ITEM # 2.0

PRELIMINARY & FINAL PLAT APPROVAL:

Western Meadows Subdivision
A 16.00 acre tract of land, more or less, being all of
Lot 18, Block 7, Texan Gardens Subdivision
Rural E.T.J.
Developer: Nordhausen Utility Construction, LLC
Engineer: Nain Engineering, LLC

REVIEW DATA

SITE LOCATION 1

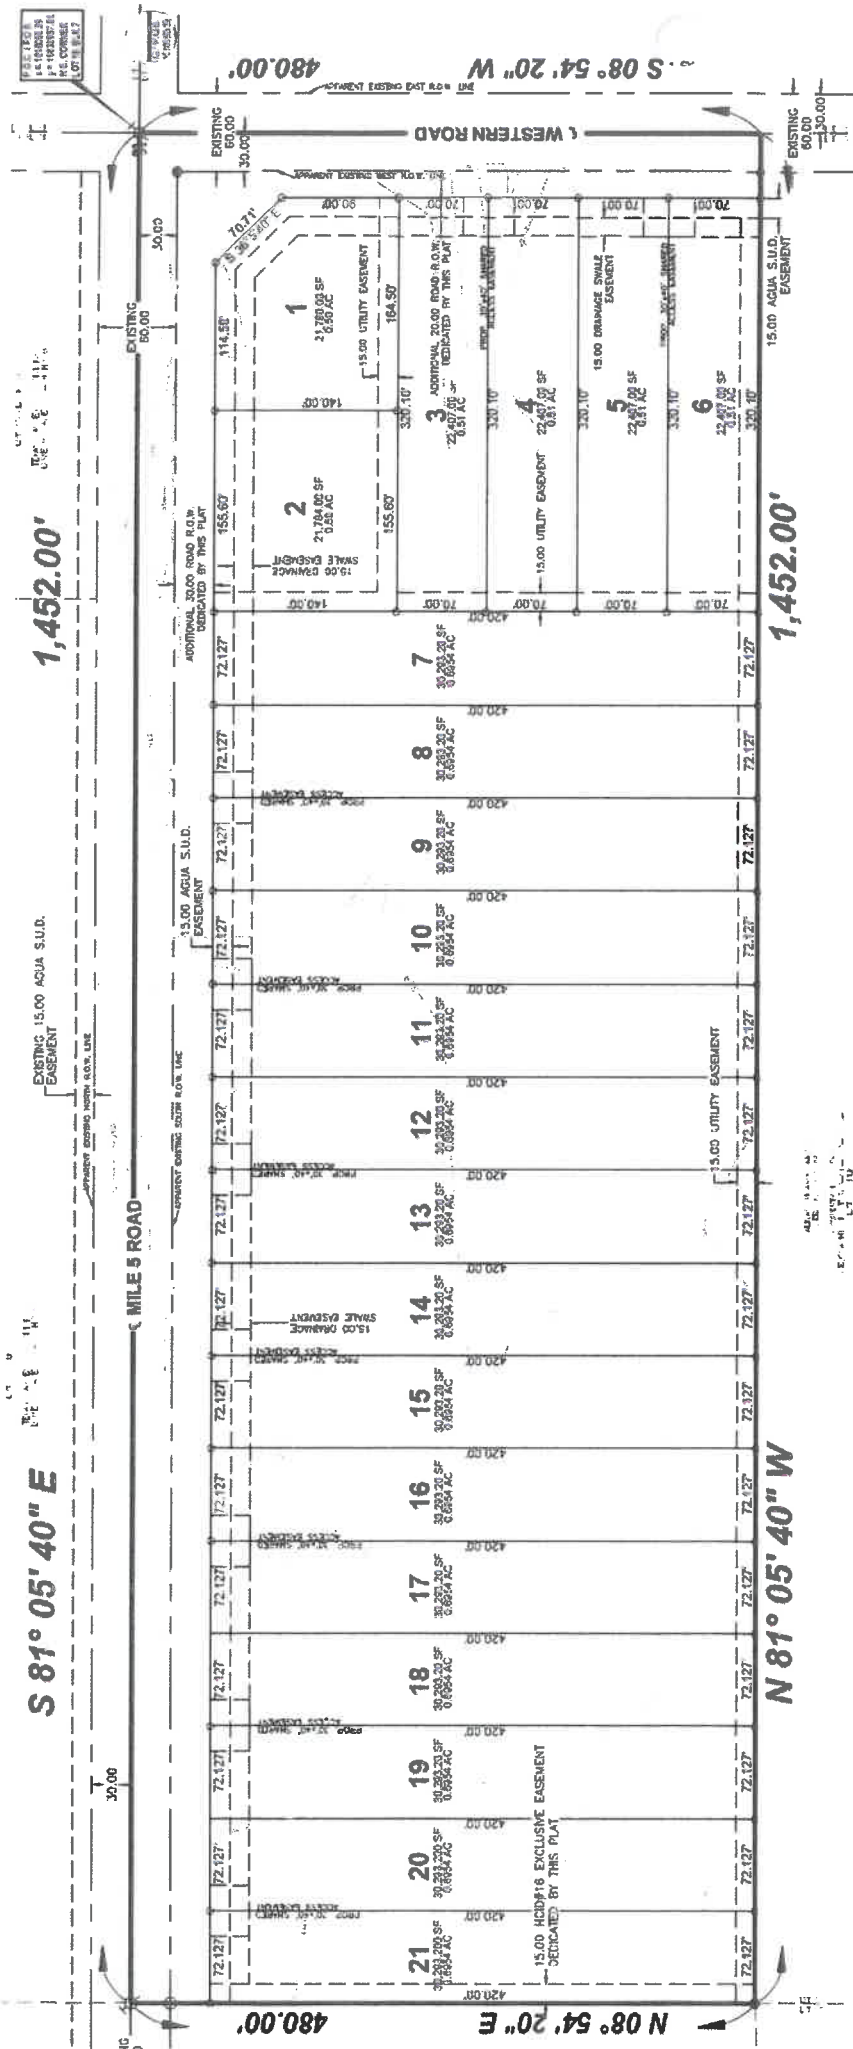
The proposed subdivision is located at the southwest corner of the intersection of Mile 5 North and Western Road (Mission Rural ETJ) – see vicinity map. The developer is proposing (21) Twenty-One Single Family Residentials lots – see plat for actual dimension, square footages, and land uses.

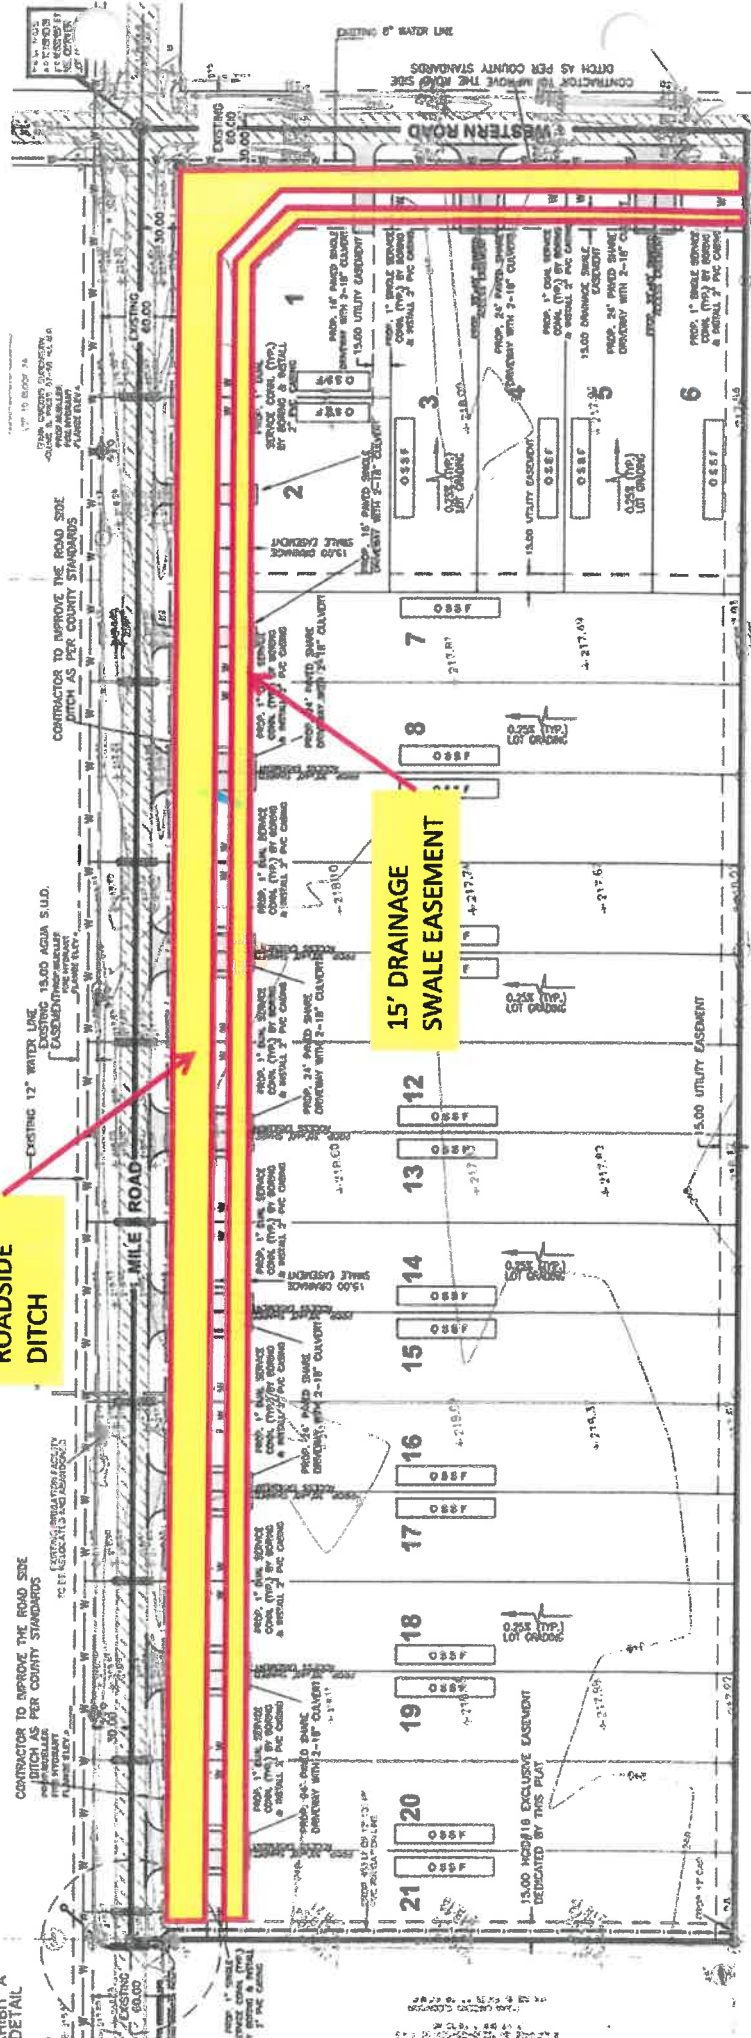
Access for Lots 1, 2, and 7-21 will be from Mile 5 North and for Lots 3-6 will be from Western Rd. The storm runoff after development will increase 7.27 cfs for a total of 16 cfs (50-year design) to be detained within the property by proposed detention areas at the front of the lots and ultimately discharging into the regraded road-side ditch. The City Engineer has reviewed and approved the drainage report.

Staff recommends approval subject to meeting the Model Subdivision Rules and meeting any comments from the County Planning Department.
